# United States Patent and Trademark Office

| APPLICATION NO.          | FILING DATE                     | FIRST NAMED INVENTOR | ATTORNEY DOCKET NO.  | CONFIRMATION NO. |  |
|--------------------------|---------------------------------|----------------------|----------------------|------------------|--|
| 10/698,638               | 10/31/2003                      | Rex Wesley Shores    | 31849.35             | 3375             |  |

#### **DETAILED ACTION**

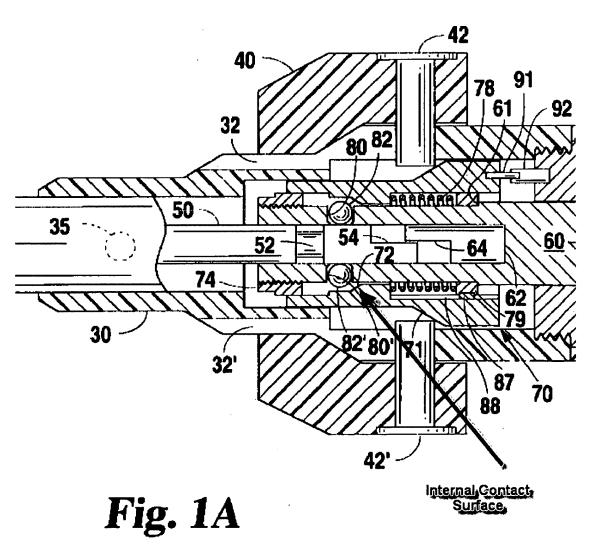
Mickel et al. disclose a coupling system, for a medical dissection tool, the coupling system configured to interconnect with a power source to a dissection tool, the coupling system comprising: a coupling shaft (Fig. 1A, ref. 60) having a proximal portion for receiving power from the power source (column 5, lines 52-58), a distal potion and a longitudinal axis, said distal portion having an external surface and defining an internal passage (Fig. 1A, surrounding ref. 54) adapted for receiving a portion of the medical

dissection tool (Fig. 1A, ref. 50), and at least one aperture (Fig. 1A, ref. 80) extending from said external surface to said internal passage; and at least one locking member (Fig. 1A, ref. 82) positioned adjacent said at least one aperture and movable through a first path in a direction at least partially parallel to said longitudinal axis into a locked position to prevent the medical dissection tool from moving along the longitudinal axis of the internal passage (column 7, lines 17-25).

The first path is created by moving the at least one locking member toward the tool shaft and in a direction parallel to the longitudinal axis. The ball will roll longitudinally with respect to the tool and move into the aperture (Fig. 1A and Fig 1B). The first path extends at an angle of approximately 45° to the longitudinal axis. The first path will extend at an angle of about 45 degrees, since the engagement sleeve (Fig. 1B, ref. 71) has an internal contact surface (Fig 1B, ref. 72) which is angled at about 45 degrees (Fig. 1B, ref. 72). The at least one locking member comprises a spherical ball (Fig. 1A, ref. 82). The at least one locking member comprises three locking members (column 6, lines 19-26). The at least one locking member comprises three spherical balls (column 6, lines 19-26). The proximal portion and said distal portion are integrally formed on a single shaft (Fig. 1A) (column 5, lines 58-63). The coupling system further comprises an engagement sleeve (Fig. 1B, ref. 71) disposed adjacent said distal portion, said engagement sleeve having an internal contact surface (Fig 1B, ref. 72) configured for engaging the at least one locking member into a locked position through the first path. The dissection tool includes a proximal end (Fig. 1A, ref, 50) and said internal passage includes an internal shoulder (Fig. 1A, ref. 64), said at least one

The system further includes a biasing member (Fig. 1A, ref. 40) urging said engagement sleeve to contact said at least one locking member to move to said locked position. The at least one locking member moves through a second path into an unlocked position. The system further comprises an engagement shaft (Fig. 1a, ref. 52) wherein at least one opening (the openings near ref. 52, Fig. 1B) in the engagement shaft holds the at least one locking member (Fig. 1B). The coupling system of claim 1 further comprises a retention member (Fig. 1B, ref. 54) residing inside the internal passage wherein the retention member is configured to couple with one end of the medical dissection tool (Fig 1B).

Mickel et al. further disclose a coupler for coupling a power source to a surgical dissection tool having a longitudinal axis, the coupler comprising: a housing (Fig. 1A, ref. 65) defining an outer surface with a portion adapted for coupling to the power source (column 5, lines 52-58) and an internal passage (Fig. 1A, surrounding ref. 54) for receiving a portion of the dissection tool, an aperture (Fig. 1A, ref. 80) defined between said outer surface and said internal passage; and at least one locking member (Fig. 1a, ref 82) disposed adjacent said aperture, said locking member moveable at least partially along the longitudinal axis from an, unlocked position disposed substantially outside said internal passage (Fig. 1A) to a locked position having at least a portion of said locking member disposed within said internal passage (Fig. 1B); and an engagement member (Fig. 1B, ref. 71) disposed adjacent said aperture for urging the locking

member into the locked position through a first path. The first path includes movement of the locking member toward the dissection tool and movement parallel to the longitudinal axis. The ball will roll longitudinally with respect to the tool and move down towards the tool (Fig. 1A and 1B). The first path is at approximately 45° to the longitudinal axis. The first path will extend at an angle of about 45 degrees, since the engagement sleeve (Fig. 1B, ref. 71) has an internal contact surface (Fig 1B, ref. 72) which is angled at about 45 degrees (Fig. 1B, ref. 72). The locking member comprises a spherical ball (Fig. 1A, ref. 82). The coupling assembly comprises two additional locking members (column 6, lines 19-26). The three locking members comprise three spherical balls (column 6, lines 19-26). The locking member moves through another path into an unlocked position. The path would be reversed in the unlocking step. The coupler further comprises a engagement shaft (Fig. 1a, ref. 52) wherein an opening (the opening near ref. 52, Fig. 1B) in the engagement shaft holds the locking member.

A coupling assembly joining a power source to a medical dissection tool having a longitudinal axis, the coupling assembly comprising: a coupling housing (Fig. 1A, ref. 65) having a proximal portion configured to receive power from the power source (column 5, lines 52-58) and a distal portion configured to receive a portion of the dissection tool (Fig. 1A, surrounding ref. 54); and a means for locking the dissection tool to the coupling housing configured to move the dissection tool within the coupling housing along the longitudinal axis. The means include the balls (Fig. 1A, ref. 82), the engagement sleeve (Fig. 1B, ref. 71), the biasing member (Fig. 1A, ref. 40), and the shaft (Fig. 1a, ref. 52) with openings (the openings near ref. 52, Fig. 1B). The coupling

housing includes an internal bore (Fig. 1A, surrounding ref. 54) configured to receive the dissection tool, and the internal bore includes an internal shoulder (Fig. 1A, ref. 64), said means for locking configured to move the dissection tool into an abutting engagement with said internal shoulder in a locked position (Fig. 1A and Fig. 1B).

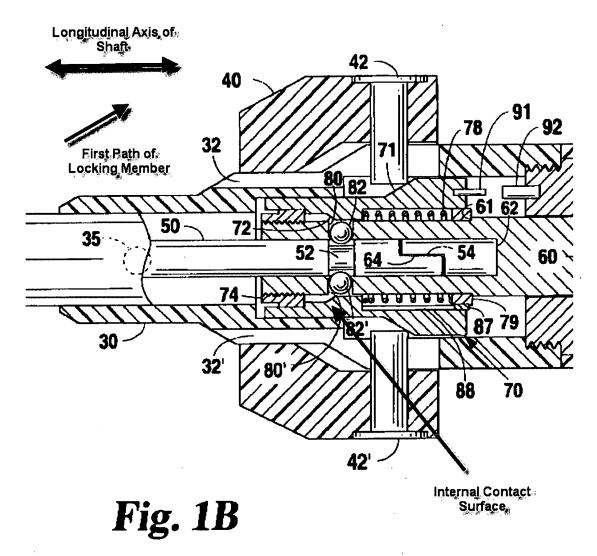
With regards to Applicant's argument that Mickel fails to teach a locking member movable through a first path in a direction at least partially parallel to said longitudinal axis in a locked position, the Examiner respectfully disagrees. The locking member (Fig.

1A, ref. 82) is movable through a first path (Figs. 1A and 1B, below, enlarged and truncated) in a direction at least partially parallel to said longitudinal axis in a locked position. Since the locking members must roll up the internal contact surface of ref. 72, they must move in the direction of the ramp, which is not transverse to the longitudinal axis of the shaft, but is at an angle with the shaft and therefore the first path is "partially parallel" to the shaft.
